SECTION 00942 - Change Order Form

Project: Old Dixie Highway Resurfacing from 71st Street to County Road 510

CHANGE ORDER NO. 1 - Final

SECTION 00948 - Work Change Directive

REUSE 16" / FM 24" OFF-SETS
OLD DIXIE HIGHWAY

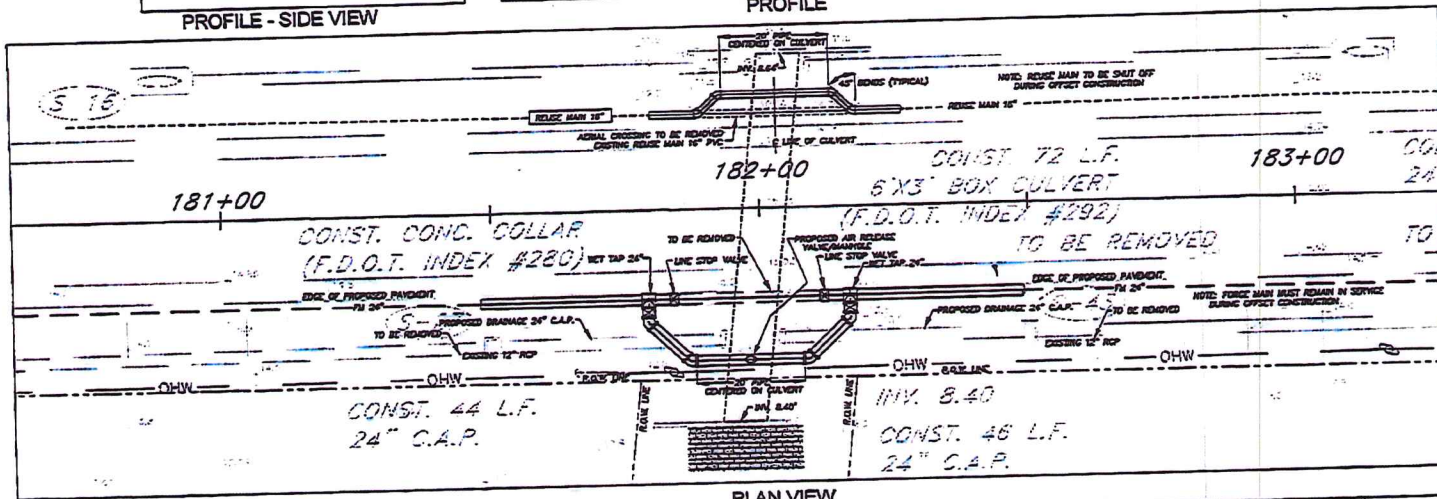
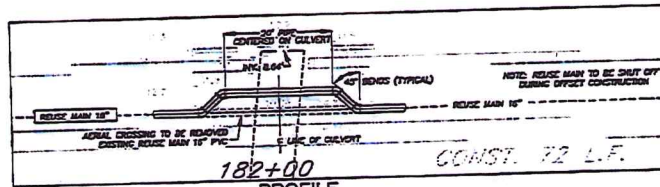
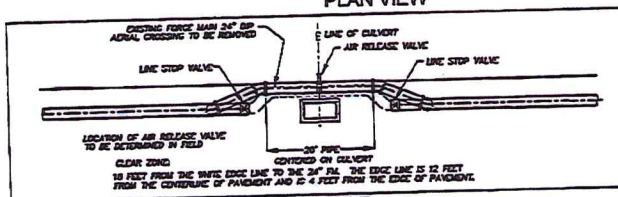
Revise the 24" Force Main as shown on the Utility plans to install the force main over the proposed box culvert in lieu of under the proposed box culvert.

REVISED: JAN 2016, 24" FM OFF SET RELOCATED OVER TOP OF CULVERT -ART-

The installation of the 24" Force Main over the proposed box culvert in lieu of under the proposed box culvert will eliminate extensive dewatering and will eliminate one air release valve and two air release valve boxes.

Old Dixie Highway from 71st Street to County Route 510
Work Change Directive No. 3

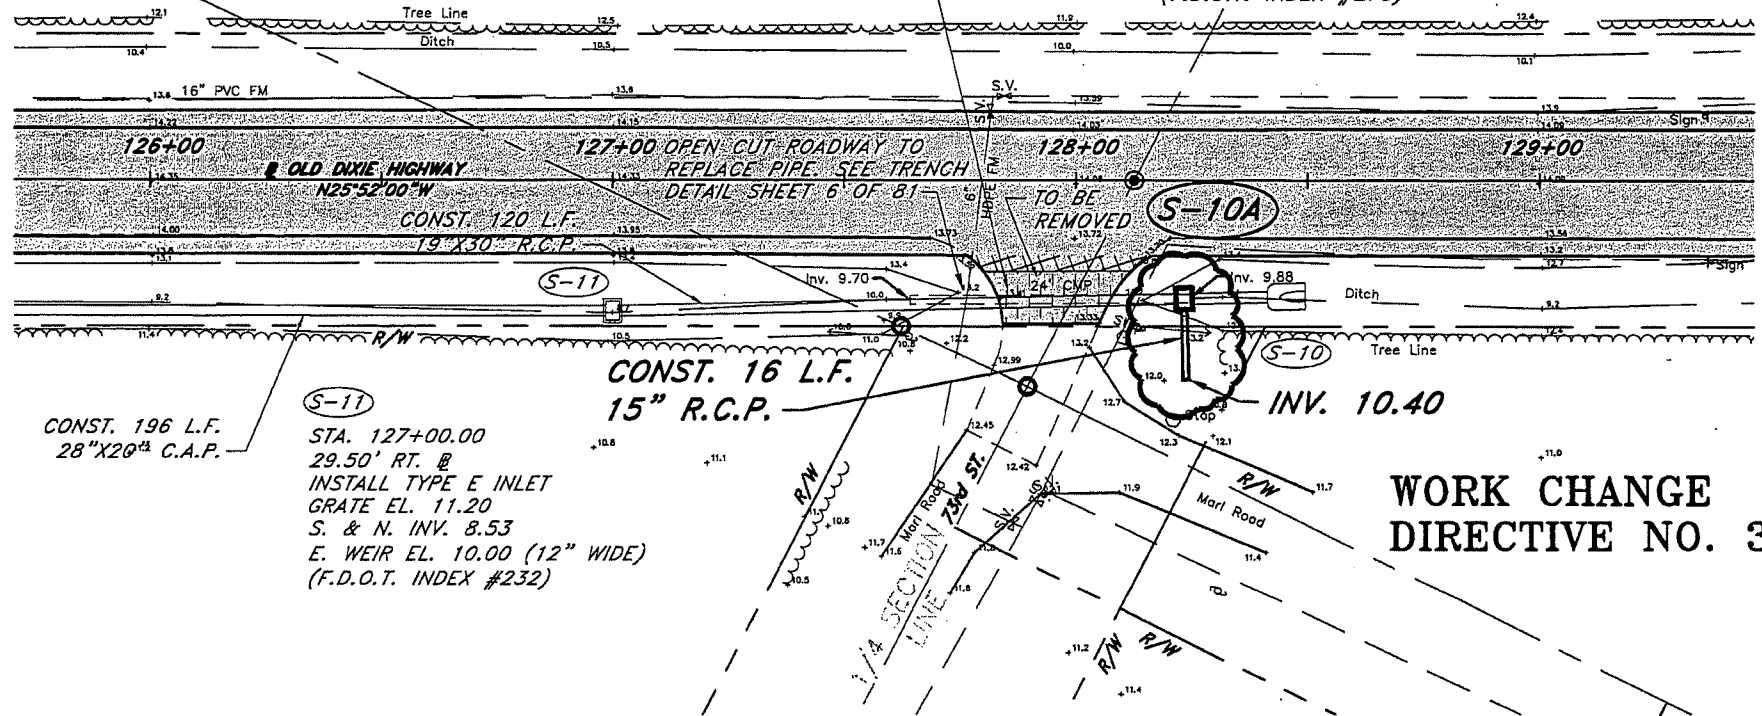
Add a Type E Inlet and 16 LF of 15" RCP.

STA. 128+23.47
26.65' RT. @
INSTALL TYPE E INLET
GRATE EL. 13.35
N. & S. INV. 10.00
E. INV. 10.20
(F.D.O.T. INDEX #232)

CONST. 16 L.F.
15" R.C.P.

The 15" RCP is being added to extend into a ditch near 73rd Street. This pipe will drain into a Type E Inlet that is in line with the 19" x 30" RCP that was previously installed with this project.

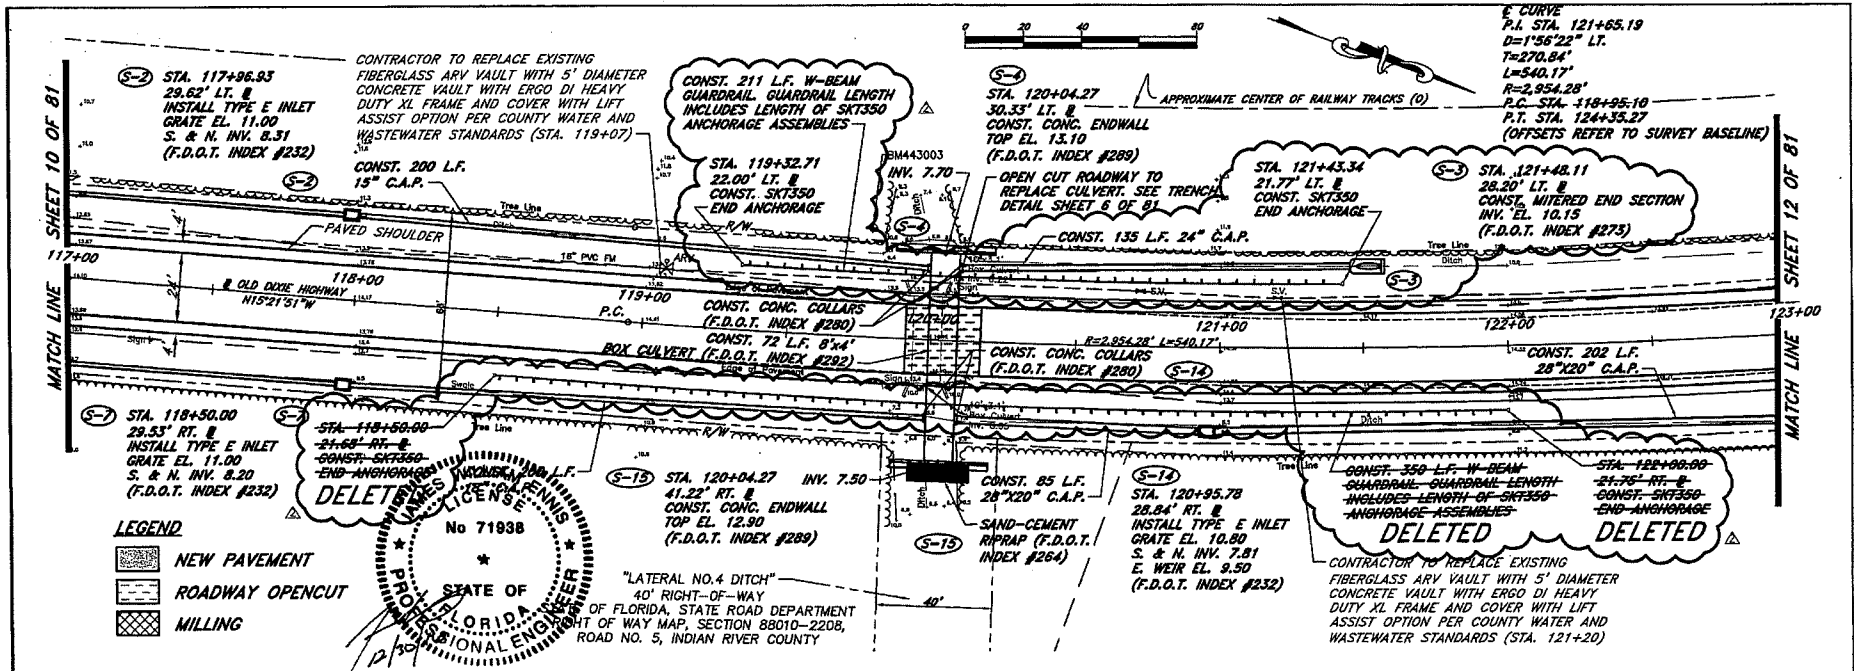
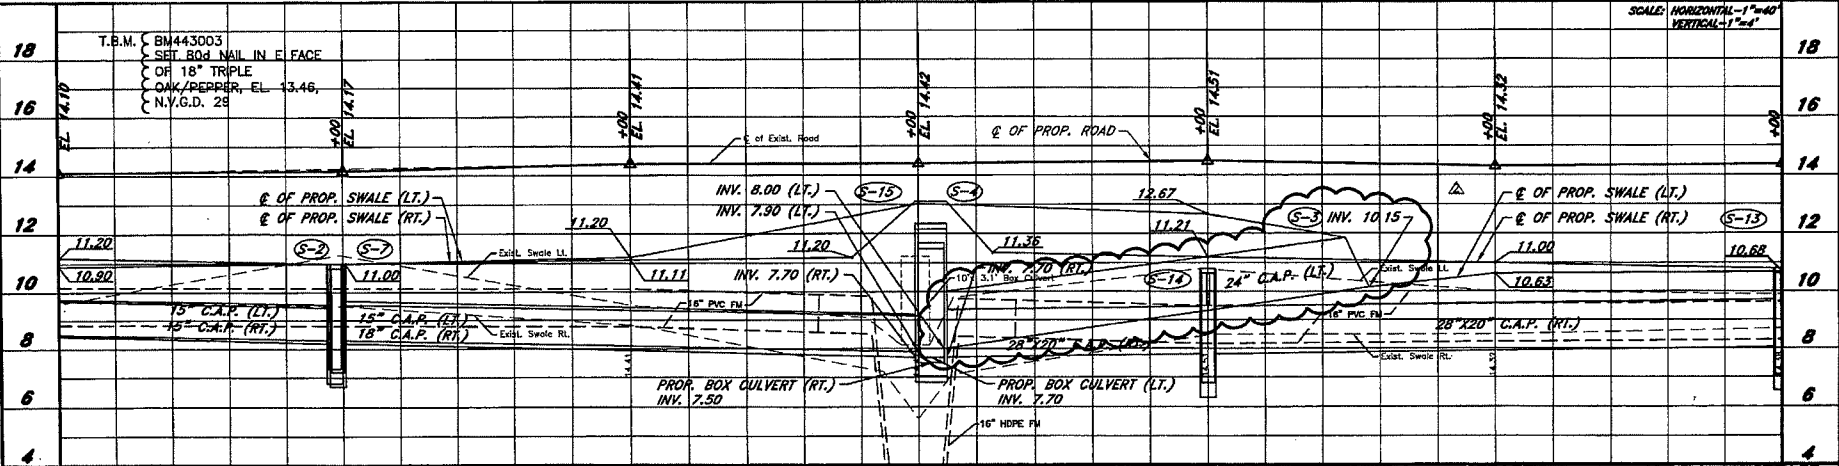
Based upon a review of the field conditions as a result of an unforeseen utility conflict and the required design criteria for guardrail installation a modification to the guardrail design was found to be warranted for the guardrail protecting the box culvert crossing underneath Old Dixie Highway at approximate project station 120+00. This change resulted in the reduction of guardrail installation required along with the extension of the side drain extending north from the box culvert along the west side of Old Dixie Highway.

The purpose of this work change directive is to implement Plan Revision #2 into the project plan set and to compensate the Contractor for all out of scope work and extend the Contract time for impacts related to the additional work. All work falling under an established pay items shall be addressed by overrun/underrun of that pay item.
